SERVICE BULLETIN

EC02-018a

LOW POWER/POOR RUNNING AND/OR MIL 'ON' WITH FRONT O2 SENSOR/TRANSMISSION GEAR DTC STORED

APPLIED VEHICLE: 2002 Altima (L31) with QR25DE ONLY

Figure 1a

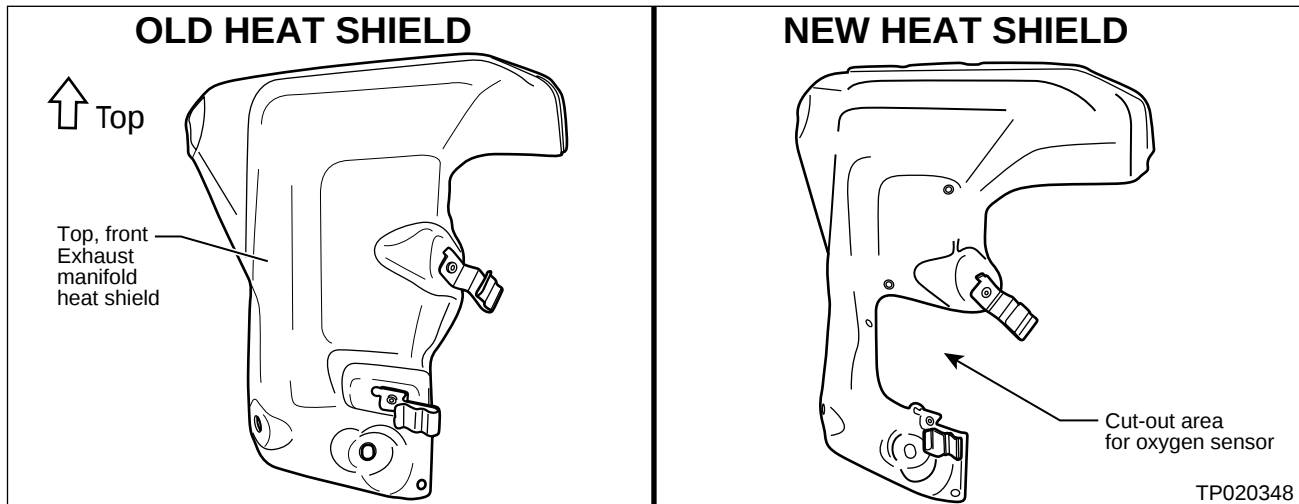
- A. If the heat shield looks like the one in Figure 1a, perform the QR25 campaign (NTB03-070a or later revision). This includes replacing the heat shield (Figure 1b).

NOTE: The new heat shield shown in Figure 1b is an important part of the repair to prolong the life of the replacement oxygen sensor.

- B. If the heat shield looks like the one in Figure 1b, the heat shield does NOT need to be replaced. Go to step 2 (below).
